WALDEN PRESERVE 2, FILING NO. 4

LOCATED IN THE SW1/4 OF SEC. 14, THE SE1/4 OF SEC. 15, THE NE1/4 OF SEC. 22 & THE NW1/4 OF SEC. 23,
ALL IN T. 11 S., R. 66 W. OF THE 6th P.M., EL PASO COUNTY, COLORADO

PCD File No. SF-18-034

DRAWING: 17094FP4.DWG PAGE 2 OF 2

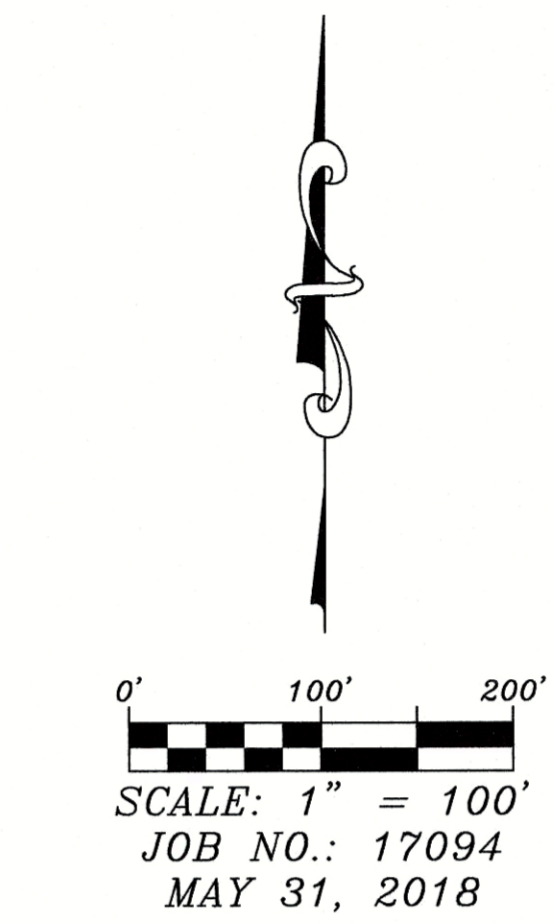
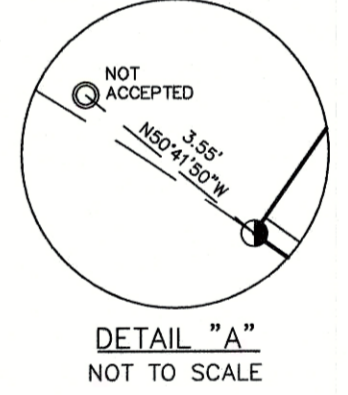
Provide a temporary turnaround. See ECM Section 2.3.8.C for the criteria and language that needs to be included in the plat.

Provide a drainage easement for the drainage ways.

access or more than 3 lots is considered a roadway and not a driveway.

Delineate the 100yr flood plain.

Provide the street name.

An additional setback line has been shown in the PUD and preliminary plan. Please show the setback line on the final plat.

This is not necessary.
